**STATE OF NEW YORK
PUBLIC SERVICE COMMISSION**

Case 15-E-0751

**Clean Energy Parties: Solar Energy Industries Association, Coalition for Community Solar
Access, Natural Resources Defense Council, New York Solar Energy Industries
Association, Pace Energy and Climate Center, and Vote Solar**

**Comments on Whitepaper Regarding Future Value Stack Compensation, Including
Avoided Distribution Costs**

Figure 1. 2017 Top 10 Distribution Peak Hours Across New York Utilities

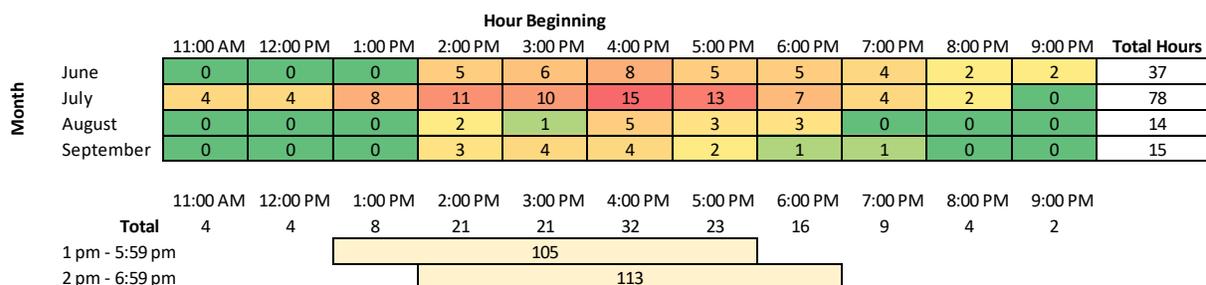
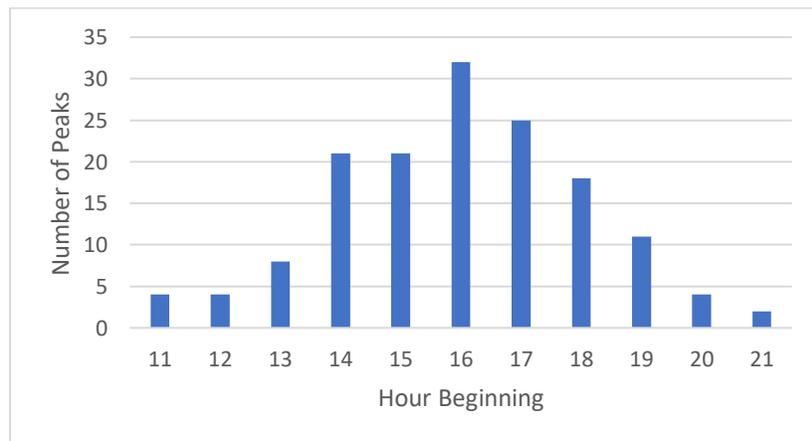
Hours: We believe that the 2 pm to 7 pm window is at least as appropriate, if not more so, than the 1 pm to 6 pm window. Again, based on 2017 utility data, more distribution peaks occurred in the range of 2 pm to 7 pm, rather than 1 pm to 6 pm.⁸ For example, 22% of the top ten summer hours in 2017 occurred after 6 pm. By contrast, only 11% occurred before 2 pm, and all of the peak hours occurring before 2 pm in 2017 were in ConEdison’s territory. Indeed, 78% of the distribution peak hours in 2017 were between 2-7 pm. The distribution of hours and months is shown in the table and graph below.

As the chart below demonstrates, the peak hours on the distribution system frequently extend into the early evening hours. We expect that the peak period may shift even later in the future as additional solar comes online.

Given that the bulk of the distribution system peaks for which data is available occur in the 2 pm -7 pm timeframe, CEP recommends that the 2 pm – 7 pm peak period definition be maintained, as it is the most accurate reflection of the current data and likely future trends, and also in order to incentivize resources that can generate later in the day (such as storage-paired solar and solar arrays with tracking systems). However, to encourage some systems to continue to reduce early afternoon peaks, we recommend that Staff also create a 1 pm – 6 pm peak window option for systems to opt into.
